Notice to All Bidders:

The attention of Bidders submitting proposals for addition to Base Security System project indicated above is called to the following Addendum to the Plans and Specifications. The revisions set forth herein, whether of omission, addition or substitution, are to be included in and form a part of the Proposal submitted.

Changes to the Statement of Work:

Building 18

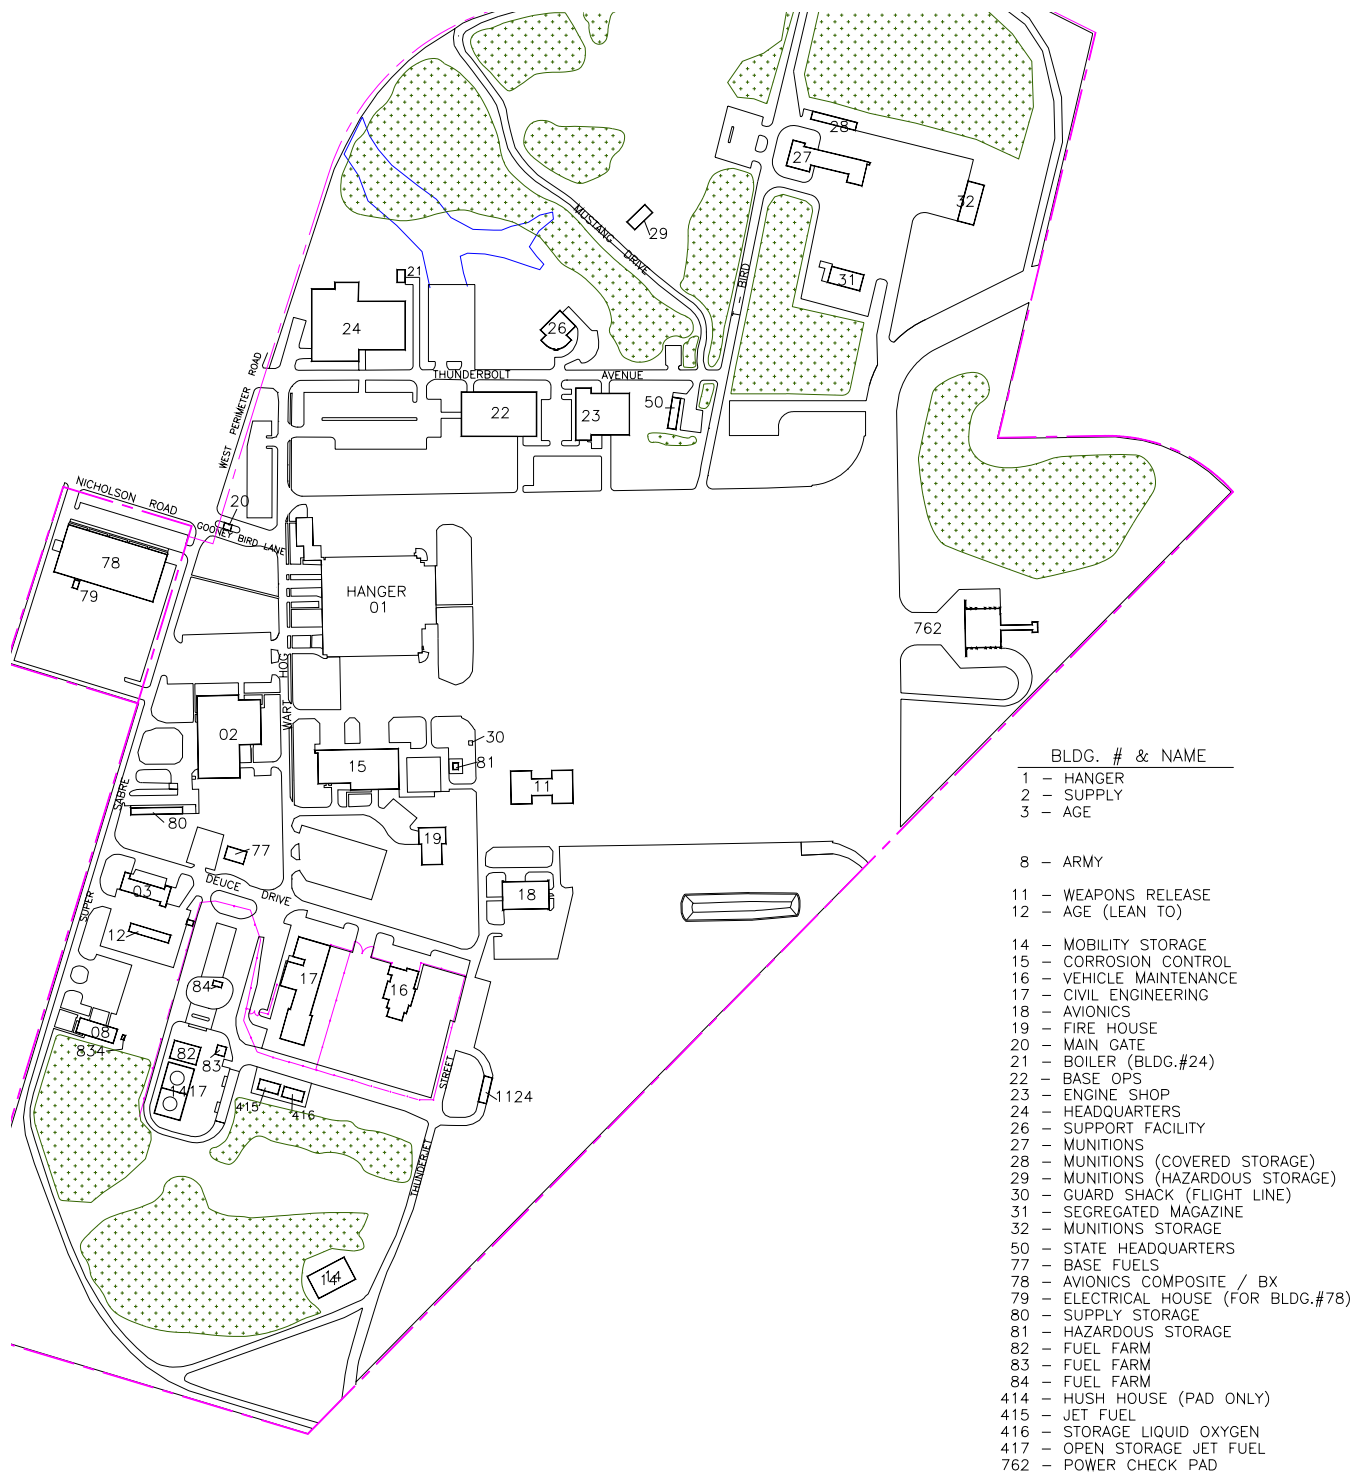
Changes to the Drawings:
